PROJECT	:	Land adjacent Sefter School House, Sefter Road, Pagham
NOTE REF.	:	Acl640/21023/TN
NOTE TITLE	:	Additional Information requested by the LLFA
AUTHOR	:	Tafari Lewis
APPROVED	:	Tafari Lewis
DATE	:	11 th March 2022

This file note has been produced to provide additional information to Arun District Council (ADC) as lead local flood authority (LLFA) on drainage and flood risk for the proposed development of land adjacent Sefter School House, Sefter Road in Pagham.

A Drainage Strategy and SuDS Statement (DS) was produced by Adama Consulting Limited (ACL) in October 2021 (report ref; Acl598/21023/DS Issue 5) which was submitted supplementary to a discharge of conditions application to ADC under reference P/15/22/DOC.

Catchment Areas

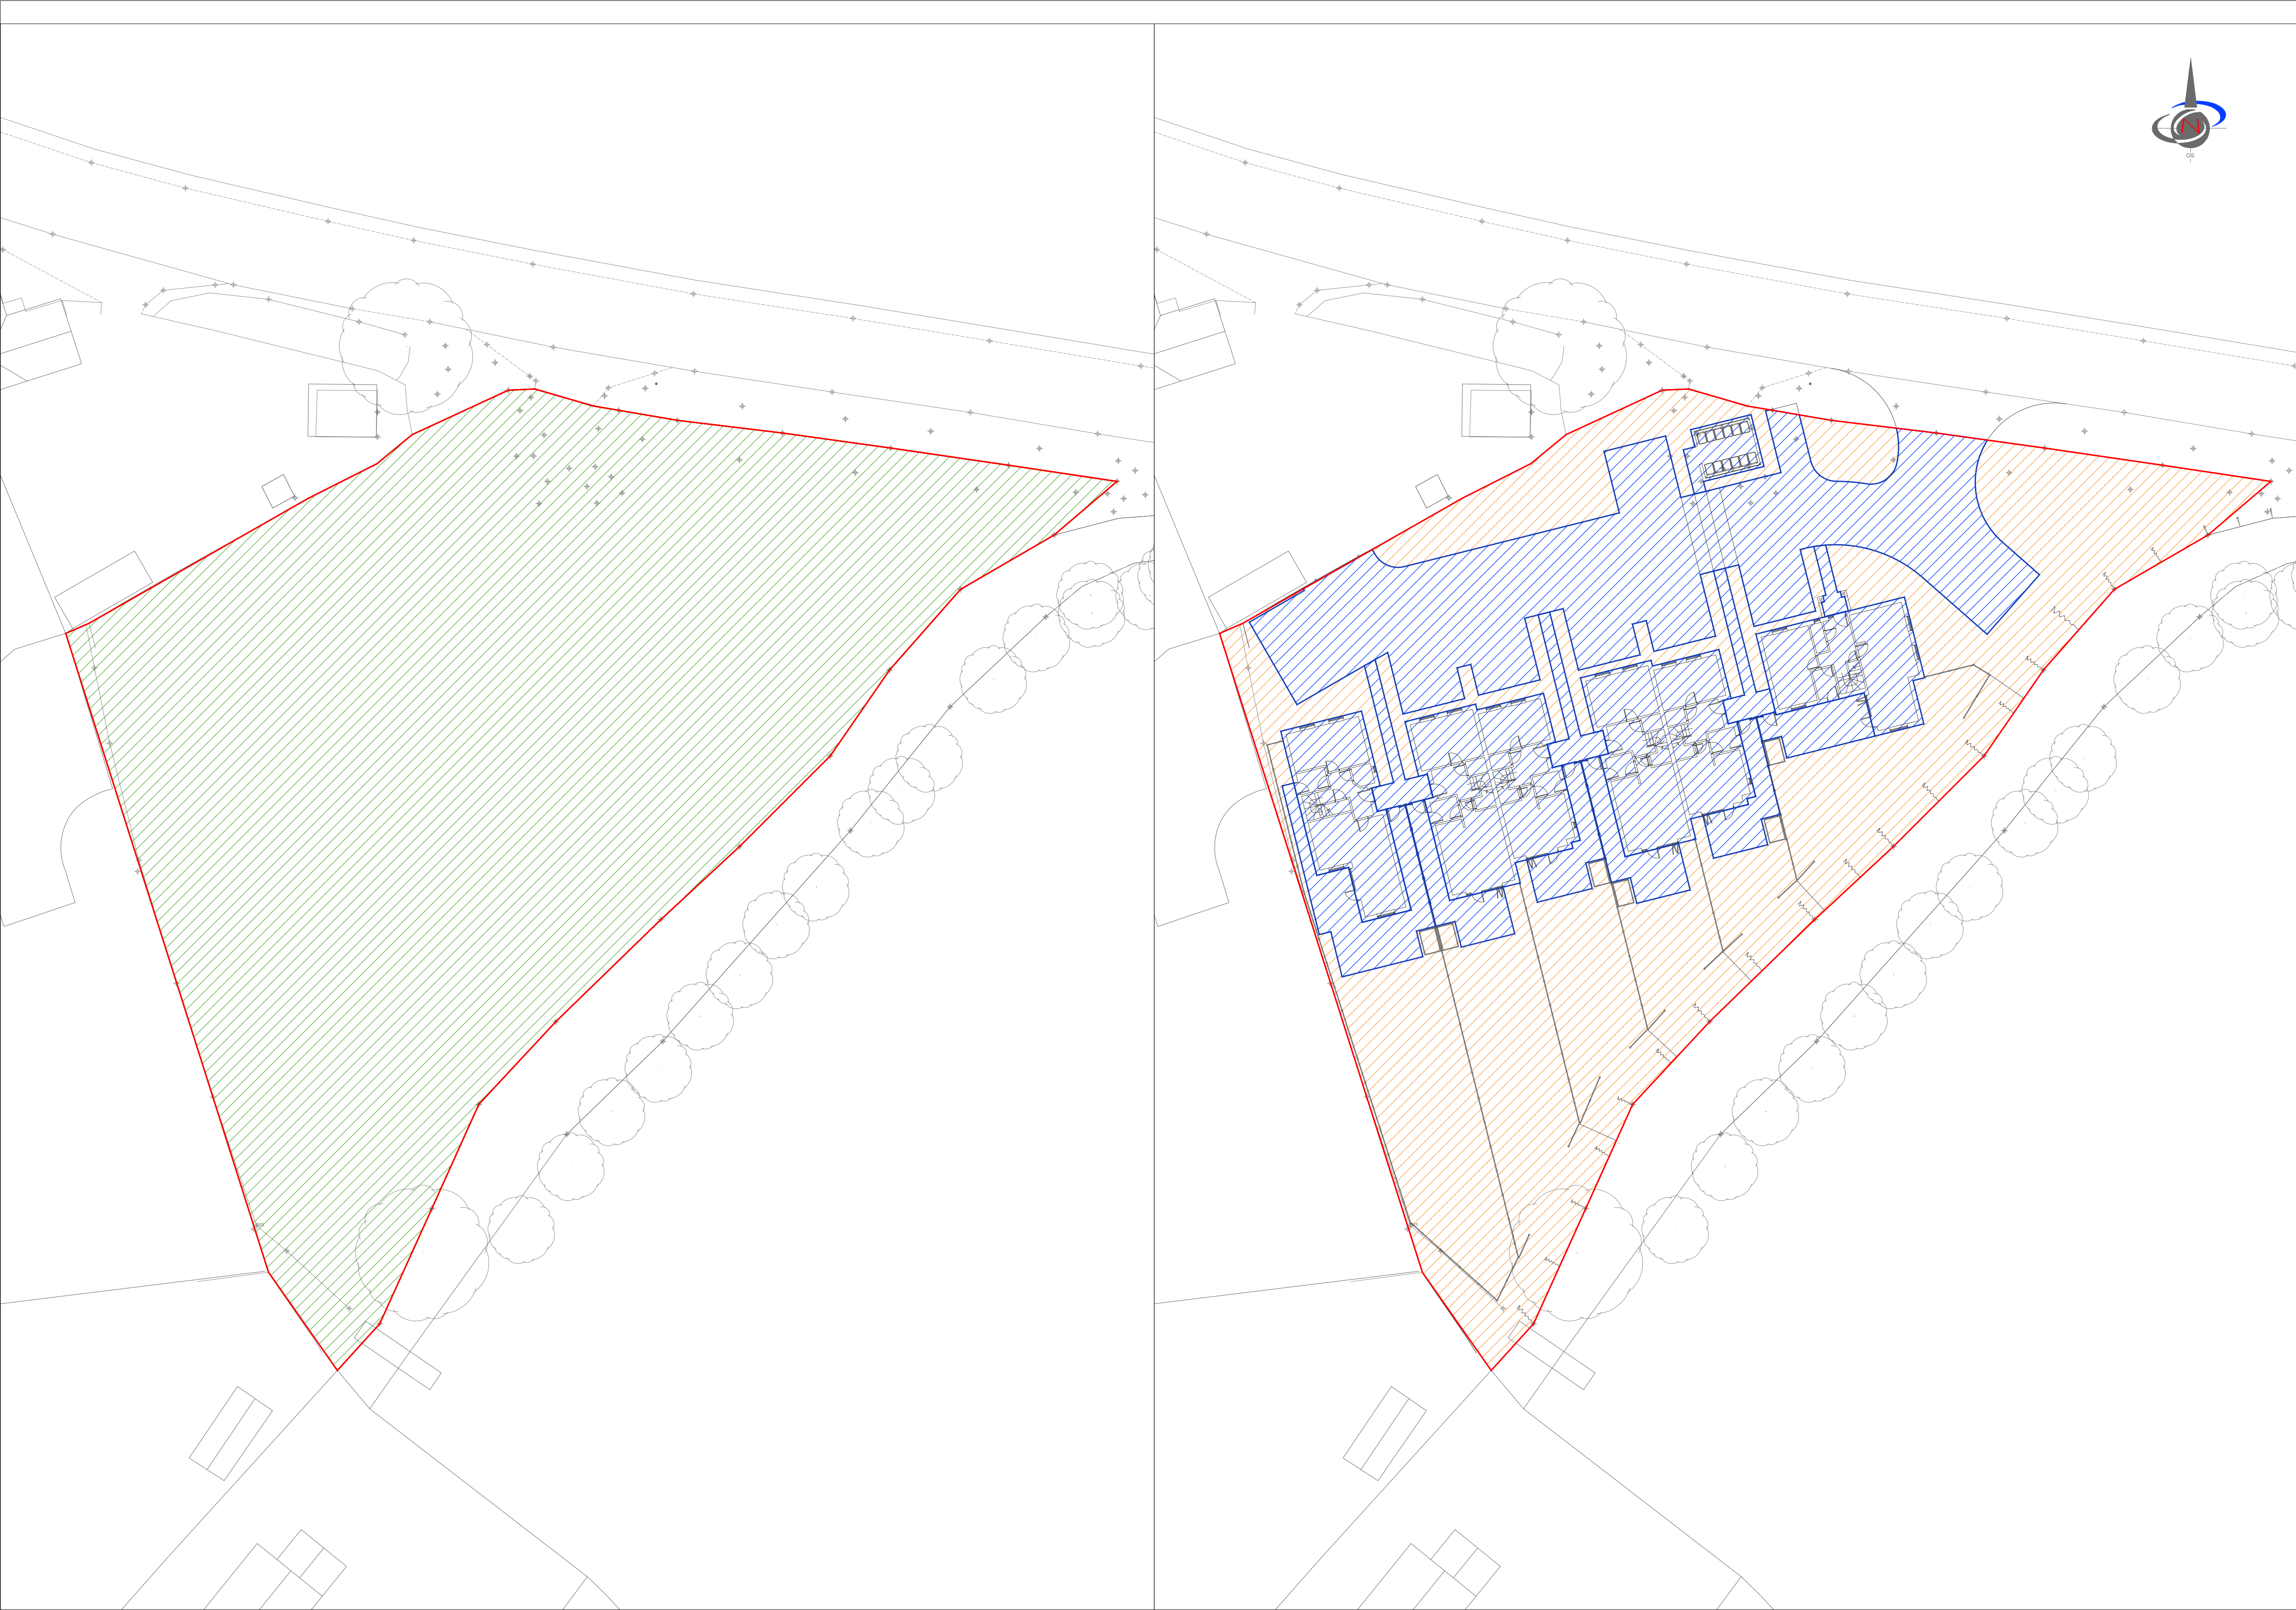
"The catchment area diagram in Appendix F has been cut and does not show the full extents of this plan. Please provide the full plan."

The full plan has been provided within **Appendix C**.

Scale	1:200 on A1	Drawn	MD
Date	10/03/2022	Checked	TL
File	21-023-Acad-400	Drawing No	21-023-400
		Rev	-

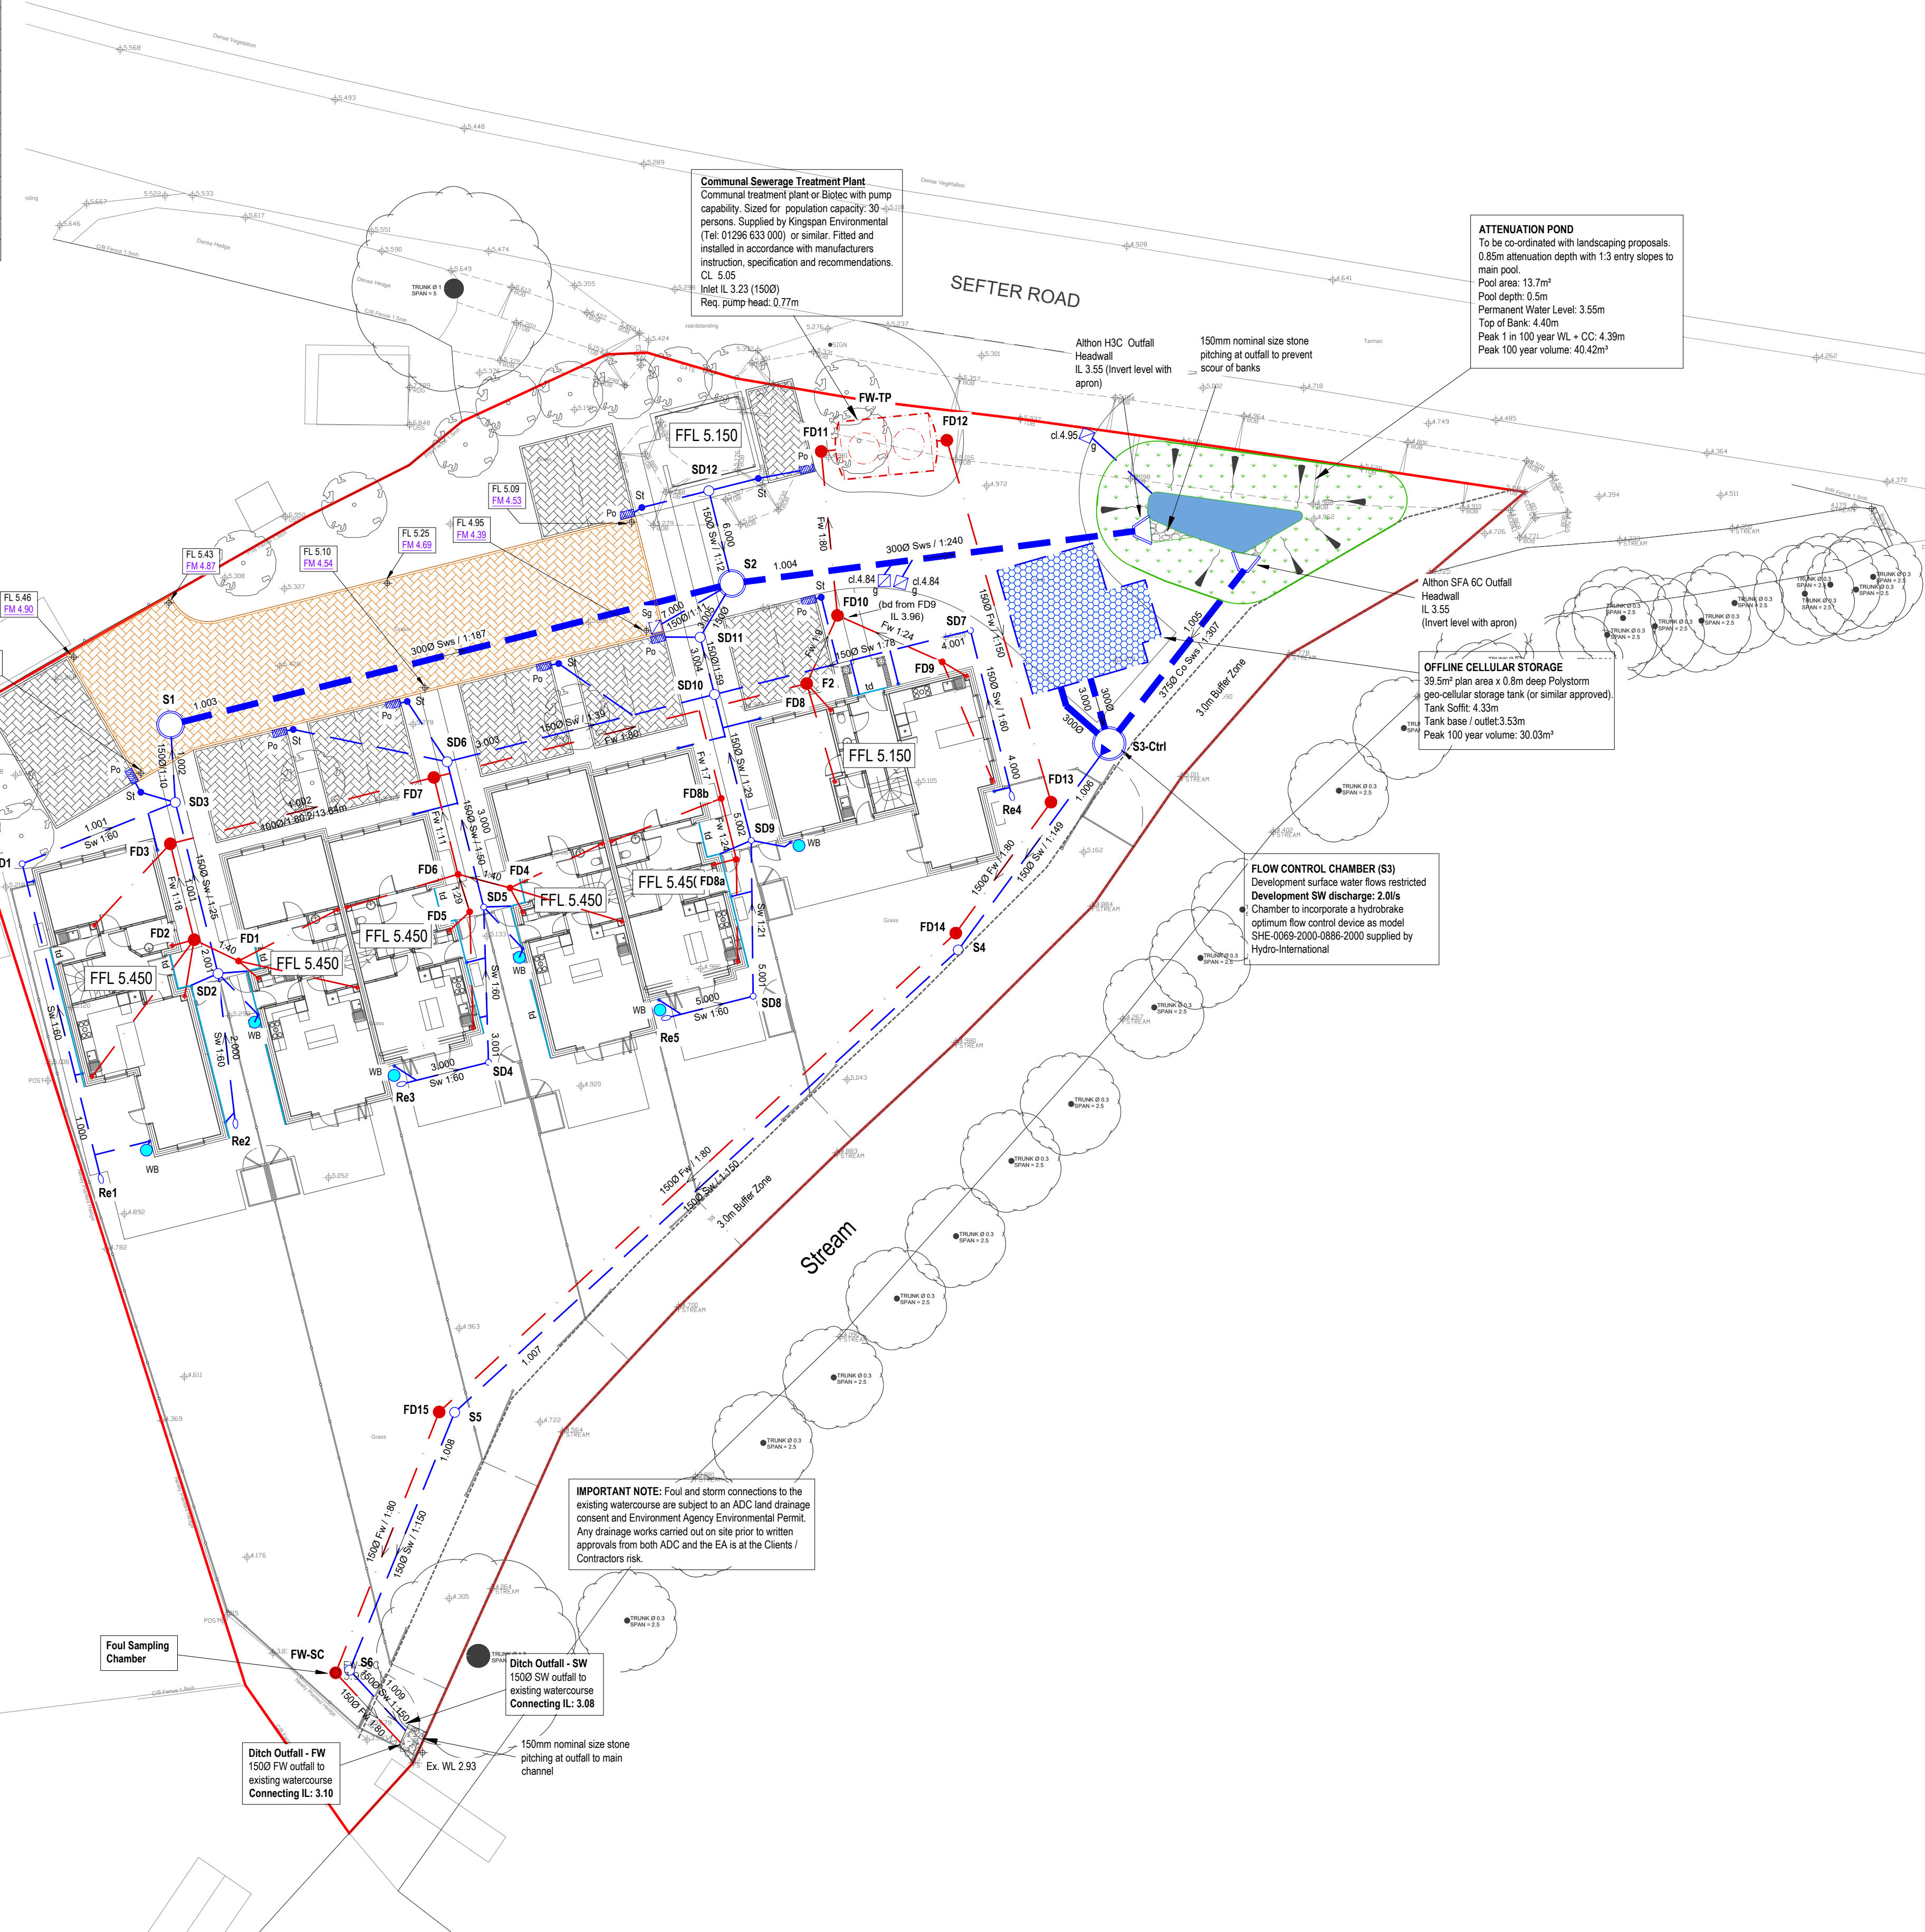
"Finish and formation level of permeable paving must be labelled on layout plan".

"Please label gully cover levels on plan".

"Hydrobrake unit reference must be stated on plan".

"Please show connections from permeable paving areas to the piped network."

Finished and formation levels for the main access permeable paving have now been included on the updated drainage layout plan.
